ARM CoreSight™
DAP Lite (TM940)
Errata Notice

This document contains all errata known at the date of issue for revision r1p2 of CoreSight DAP Lite

507413: [SW JTAG Dual-mode Debug Port] Unsynchronized clock domain crossing in SWJ-DP

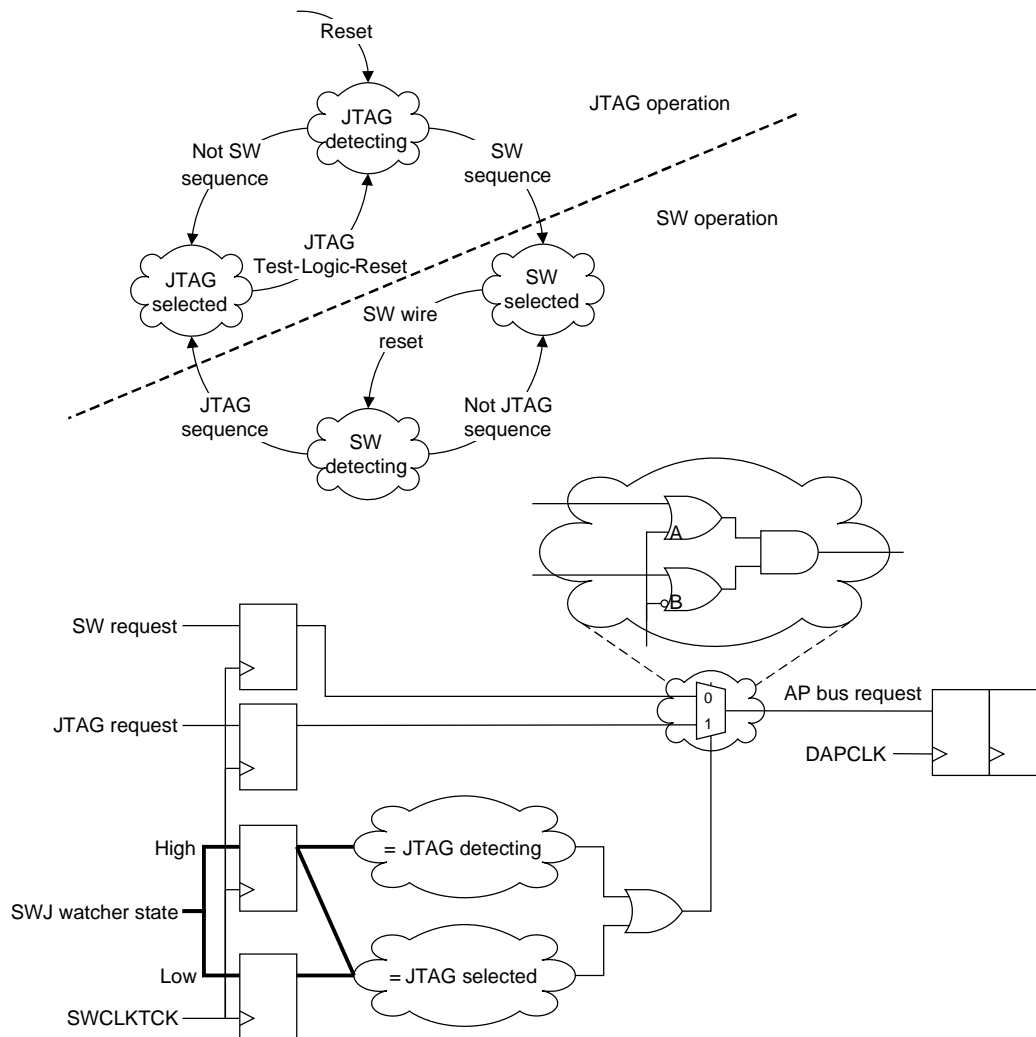
A combinatorial path exists in control signals crossing the asynchronous clock boundary between SWCLKTCK and DAPCLK. This logic might be implemented in a manner which is unsafe when crossing between asynchronous clock domains.

When switching between JTAG and Serial Wire modes of operation, or immediately following a JTAG reset operation, a single unexpected transaction might be performed by the SWJ-DP.

The diagram below illustrates the conditions necessary for this erratum.

The SWJ-DP unit implements a watcher module which drives a state machine that watches for the sequence to switch from JTAG to Serial Wire (SW) operation and back. The state machine starts in JTAG operation and searches for a SW selection sequence. If the sequence is met then it switches to SW operation, otherwise it switches to JTAG operation as soon as the sequence is broken. From JTAG operation it watches for the SW selection sequence again if a JTAG reset command is issued by transitioning into the JTAG Test-Logic-Reset state. Similarly, once in SW operation, it starts watching for the JTAG selection sequence if a SW wire reset is issued, and either stays in SW operation or switches to JTAG operation depending upon whether the sequence is met.

If the watcher switches from JTAG operation to SW operation or back again, it can cause a glitch on the AP bus request signal, causing an unexpected access to a DAP Access Port (AP), such as the APB-AP. When the mode of operation switches, both the SW request and JTAG request signals will be Low. However, it is possible for the multiplexer which switches between these two signals to cause a glitch on its output if it is implemented as an AND of ORs structure, with a significant wire delay between points A and B of the select signal shown in the diagram above. The presence of such a delay might cause both OR gates to be asserted simultaneously, causing a glitch on the output of the AND gate.

For this erratum to occur, the glitch on the AP bus request signal must be significantly long for a logic '1' to be sampled in the following register. It is highly unlikely that the skew between points A and B will be sufficient to generate a large enough glitch for this to occur.

Furthermore, it is theoretically possible for such a glitch to be generated when switching between the JTAG detecting state and the JTAG selected state because of the method used to compare against the SWJ watcher state. A glitch can be caused on the following multiplexer, which can in turn cause a glitch on the APB bus request signal as described above. This case is only possible if the implementation includes a significant skew between the data arrival times of the two inputs to the OR gate driving the multiplexer.

- When tools connect to the SWJ-DP that the state of any control registers in any APs is assumed to be unknown and must be explicitly programmed with known values before using the AP.

- When implementing the SWJ-DP, some of the logic between SWCLKTCK and DAPCLK should be implemented using glitch-free logic to ensure that the implementation does not meet the conditions described above.
